COUNCIL ASSESSMENT REPORT

Panel Reference	PPSSCC-398
DA Number	672/2023/JP
LGA	Hills Shire Council
Proposed Development	Residential Flat Building Development containing 315 units.
Street Address	16-30 Dawes Avenue, 2-10 Cadman Crescent and 4-8 Hughes Avenue, Castle Hill
Applicant	Place Studio Au Pty Ltd
Consultant/s	Town Planners: BMA Urban Architects: Place Studio Access: Accessible Building Solutions BCA: J² BCA Consulting Geotechnical: CEC Geotechnical Traffic: CJP Consulting Engineers Acoustic: SLR Landscape: Zenith Landscape Design QS: Property and Building Assessments Surveyors: Azimuth Surveyors Stormwater Plans: Telford Civil BASIX: Gradwell Consulting Arborist: Jacksons Nature Works
Date of DA lodgement	11 October 2022
Number of Submissions	One
Recommendation	Refusal
Regional Development Criteria Part 2.4 and Schedule 6 of the SEPP (Planning Systems) 2021	CIV exceeding \$30 million (\$72,657,523.32 excluding GST)
List of all relevant s4.15(1)(a) matters	<ul style="list-style-type: none"> • State Environmental Planning Policy (Planning Systems) 2021 • State Environmental Planning Policy (Transport and Infrastructure) 2021 • State Environmental Planning Policy (Resilience a

Figure 1: Typical Floor Plan of Unit D-405, D-505, D-605

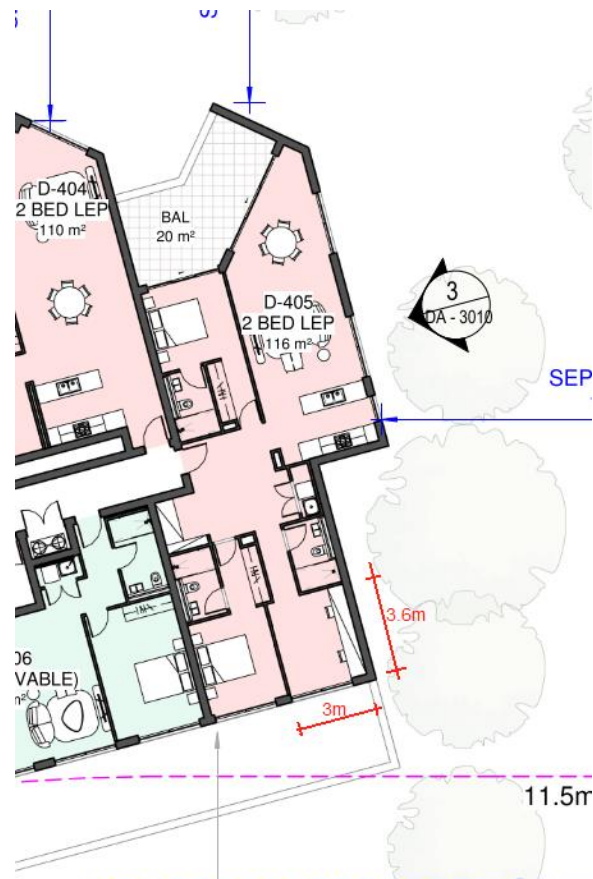
The unit schedule and Statement incorrectly includes Units D-G05, D-105, D-205, D-305 as larger 3 bedroom units despite the plans indicating these are 4 bedroom units. Further, the unit schedule and Statement incorrectly includes Units D-405, D-505 and D-605 as larger 2 bedroom units despite the plans indicating these are 3 bedroom units. Refer figure below for the typical unit layout for Units D-405, D-505 and D-605 which are identified as larger 2 bedroom units:

The plans submitted with the development application indicate that less than 40% of all 2 bedroom dwellings contained in the development will have a minimum internal floor area of 110m². Refer to the below table:

Figure 6.3 of the On-Site Detention R3 of the Upper River Catchment Trust and Council's mapping indicating stormwater drainage assets.

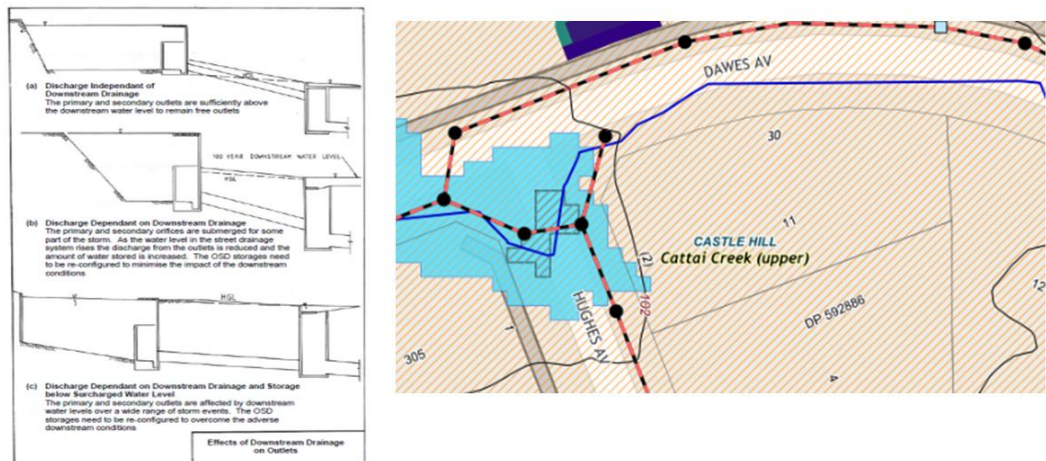
The On-Site Detention has not been designed in accordance with the On-Site Stormwater Detention R3, of the Handbook Upper Parramatta River Catchment Trust and is required to be discharged independent of downstream drainage. Refer figures below. Note Options (b) and (c) are not supported.

The submitted OSD design and calculation is incorrect as the site's slope is less than 6% requiring a site storage volume of 396m³/ha with a permissible discharge of 92l/s/ha.
